Calculation Title: Appendix E – PMP Development Version Log	Calculation No.: CDQ0000002016000041	Rev. No.: 001	Sheet: E1
--	---	------------------	--------------

Calculation Title: Appendix K – Review Board Letter	Calculation No.: CDQ0000002016000041	Rev. No.: 001	Sheet: K3
--	---	------------------	--------------

NRC Figure 11. General Storm, SPAS 1218 (Douglasville, GA [shown] & LaFayette, GA) rainfall mass curve (top) and dew point analysis (bottom)

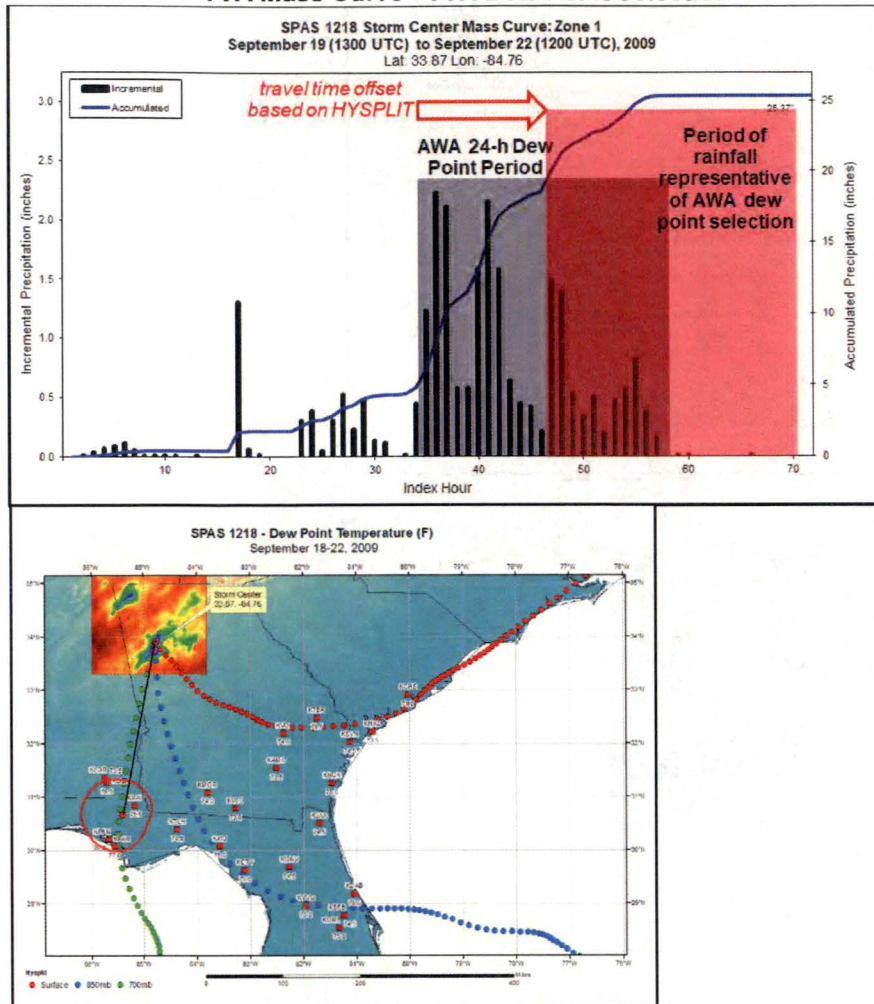
5. Additional storms which exhibit timeframe issues but do not control PMP
 - a. General Storm, SPAS 1218 (Douglasville, GA & LaFayette, GA) - Figure 11

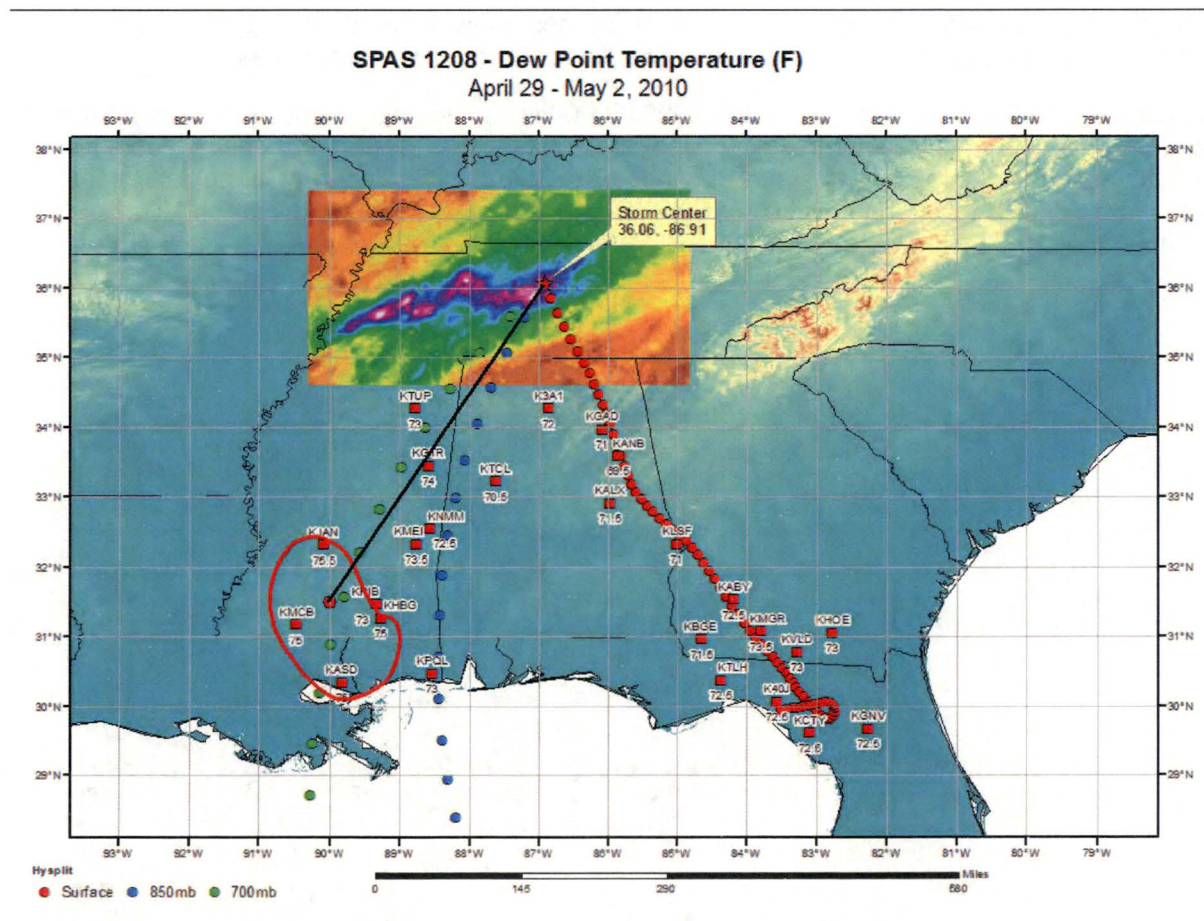
As a part of its assessment, staff reviewed the text and digital information related to the Warner Park storm representative dew point and dew point climatology provided by the licensee. Figure 404 in the Topical Report shows that a 12-h duration was used to analyze the Warner Park storm representative dew point; however, upon further review, staff believe that a 24-h duration was used.

Figure 415 in the Topical Report shows maximum average dew point data for several stations. Comparison with the "surface_summary" worksheet in the "SPAS_1208_Obs_data.xlsx" file reveals that the data plotted in Figure 415 correspond to the 24-h maximum average dew point. Also, staff confirmed that the licensee used a 12-h duration for the Warner Park dew point climatology. Therefore, it appears that the dew point duration was used inconsistently.

The 12-hour duration was used in all calculations and is the appropriate duration to use. The image included in the report documentation mistakenly plotted the 24-hour average dew point data. The correct image is provided below (TVA Figure 32). As noted by the NRC, use of either the 12-hour or 24-hour duration results in the same storm representative value, 75.0 F.

A corrected Figure 415 will be provided in Appendix F of Calculation No. CDQ0000002016000041 and will be submitted as Revision 1 to Topical Report TVA-NPG-AWA16 (TVA Calculation CDQ0000002016000041).
